# PRELIMINARY DECISION United Energy distribution determination 2016 to 2020

## Attachment 11 – Service target performance incentive scheme

October 2015

This attachment forms part of the AER's preliminary decision on United Energy's revenue proposal 2016–20. It should be read with all other parts of the preliminary decision.

Figure 11.2 Historical SAIDI

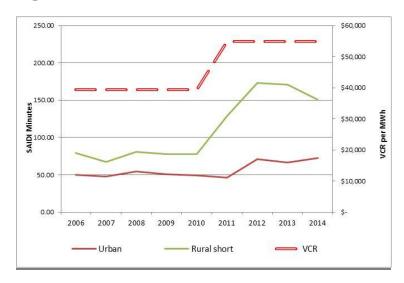
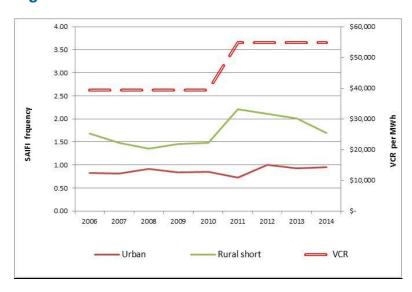
We consider that performance targets should not be modified due to a change in the VCR. Our review of United Energy's regulatory proposal found little evidence to suggest that a change in VCR results in an immediate change to reliability performance. United Energy asserts that applying a lower VCR for capex purposes will reduce its reliability performance in 2016–20. In contrast, its historical reliability performance shows that there is limited or no immediate or close correlation between

the two variables (see Figure 11.2 and Figure 11.3), at least not within 5 years from the change in VCR. That is, a 40 per cent increase in the VCR in the current period made little difference to United Energy's reliability performance. In fact, United Energy's level of supply reliability under the scheme during the current period deteriorated from the previous period, showing an outcome opposite to its contention.

As such we consider that United Energy has not demonstrated that its assertion that reliability will decline immediately in the 2016–20 regulatory control period is due to a lower VCR.
